CORRECTIVE MEASURES STUDY WORK PLAN RATIONALE FOR NO FURTHER ACTION
SOLID WASTE MANAGEMENT UNIT 43 (SWMU 43) ZONE A WITH TRANSMITTAL CNC
CHARLESTON SC
11/27/2000
CH2M HILL

CORRECTIVE MEASURES STUDY WORK PLAN

Rationale for No Further Action **Solid Waste Management Unit 43, Zone A**

Response to SCDHEC Comments Dated September 19, 2000 from Mr. Mansour Malik,
Division of Hydrogeology and Dated September 20, 2000 from Ms. Susan Peterson,
Corrective Action Engineering Section on the
CMS Work Plan; Rationale For No Further Action; SWMU 43, Charleston Naval Complex

Figure 2-3
SWMU 43
 Sample Locations and Zone L Features

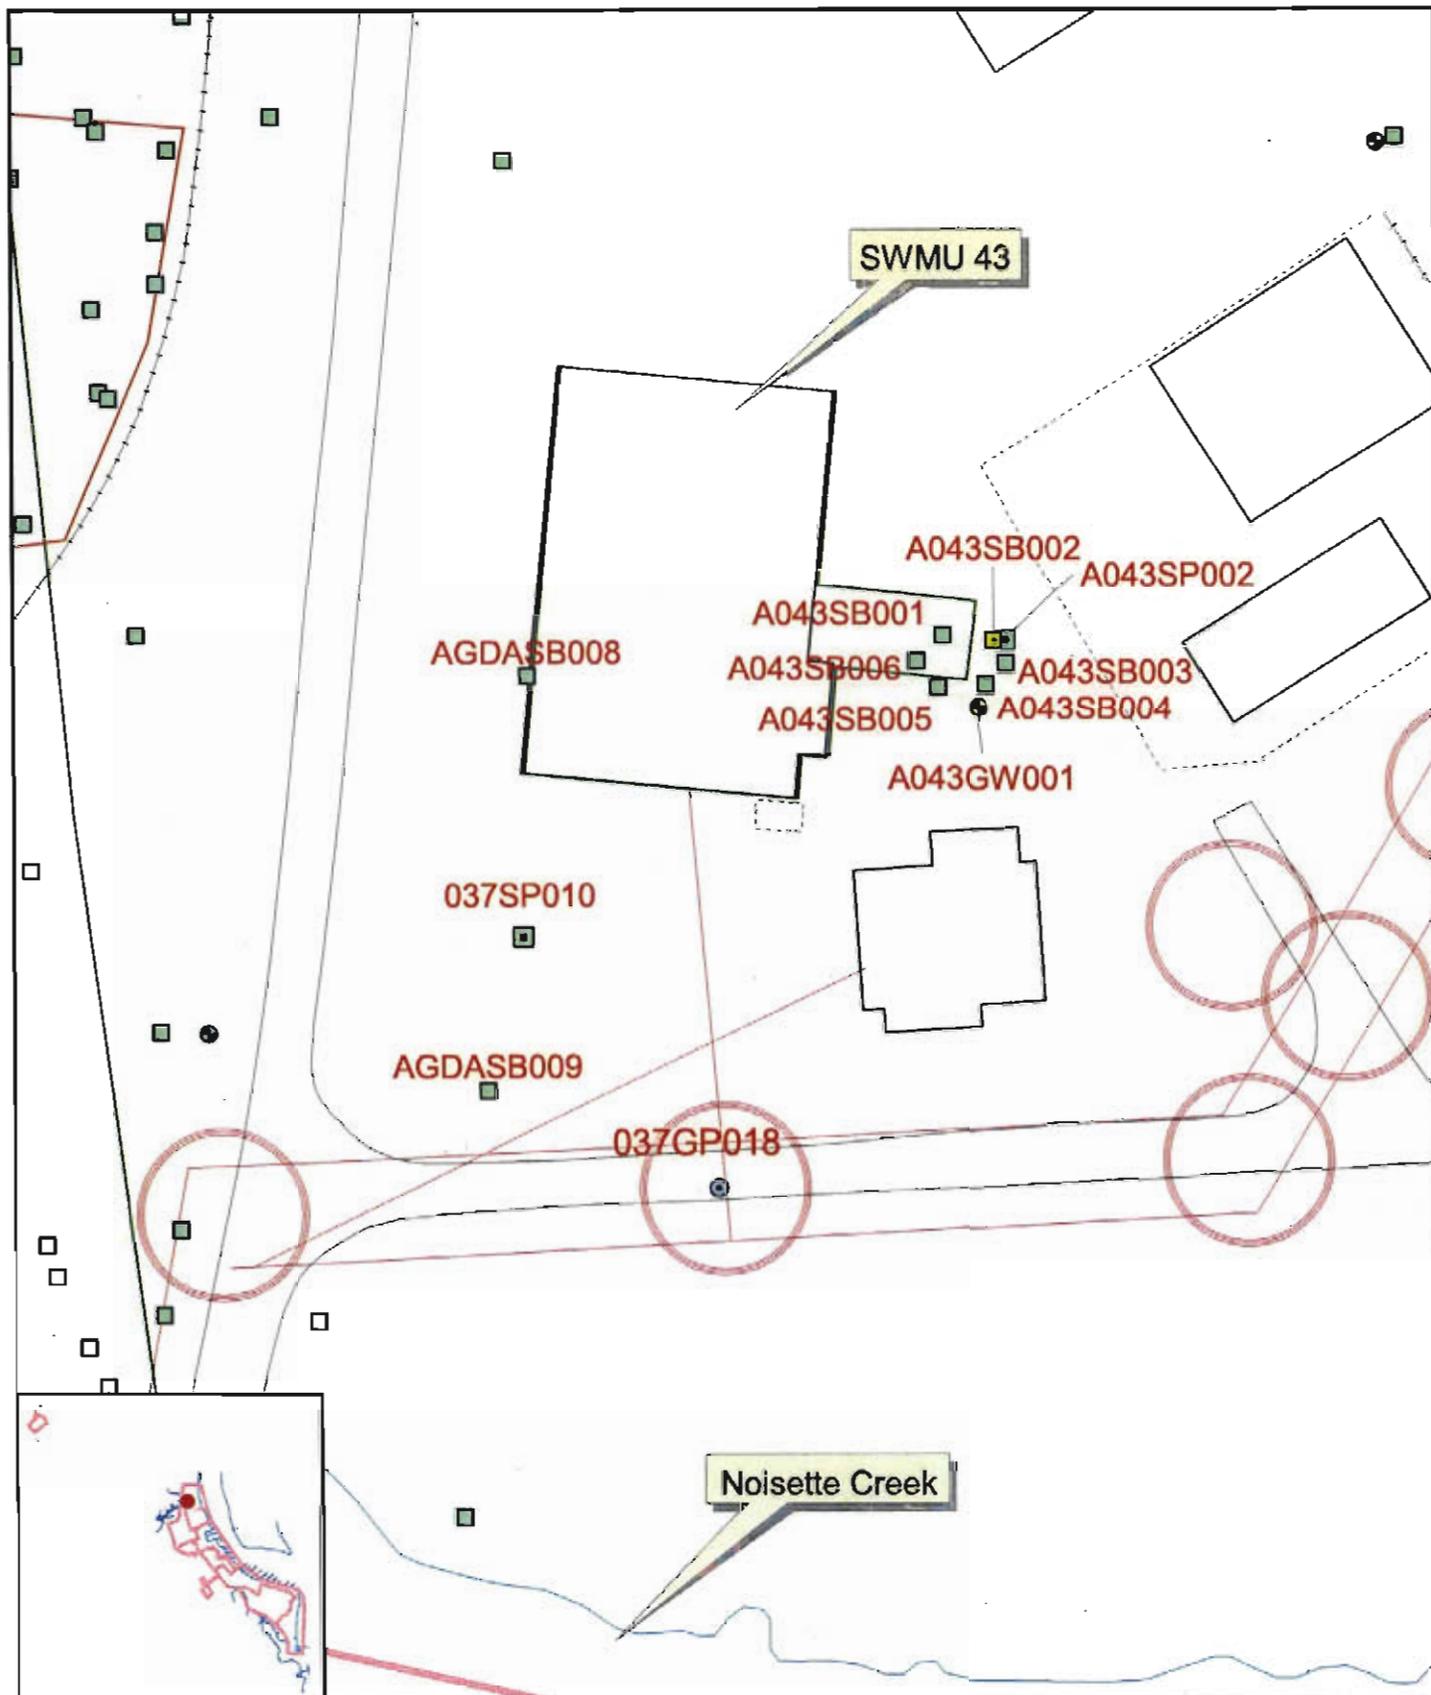
- 6. Figure 2.3 (in this CMS-WP) lacks the surface runoff and the groundwater flow directions. Please revise and include information.**

Response: Because there is no groundwater contamination at this site, groundwater flow direction is immaterial. Because there is no surface soil contamination at this site, surface water runoff direction is immaterial. Neither of these features need to be added to the figure.

Please revise Figure 2-3 to differentiate the sanitary sewer system and the stormwater system lines. In addition, more lines exist that are not included on this figure. Please revise figure 2-3 to include all lines.

Figure 2-3 only shows sanitary sewer lines. The BCT has agreed at the October 2000 meeting that the issue of potential linkage to the sanitary sewer does not require additional investigation. Therefore, no revisions to this figure are necessary.

- 4. Section 2.2, line 16: This document referred to the Section 10.6 Zone A RFI (April 14, 1999) report. Fig 10.6.2 (in the RFI Report) doesn't link the geoprobe locations and that of the shallow monitoring well to the stormwater and sanitary sewer system and Noisette Creek. Please be advised to incorporate pertinent information on the figures in this CMS-WP Report.**

Response: Figure 2-3 of the CMS work plan for SWMU 43 presents the location of shallow monitor well MW A034GW001 and Geoprobe boring locations installed as part of the SWMU 37 investigation at SWMU 43 with respect to the storm sewer, sanitary sewer, and Noisette Creek.
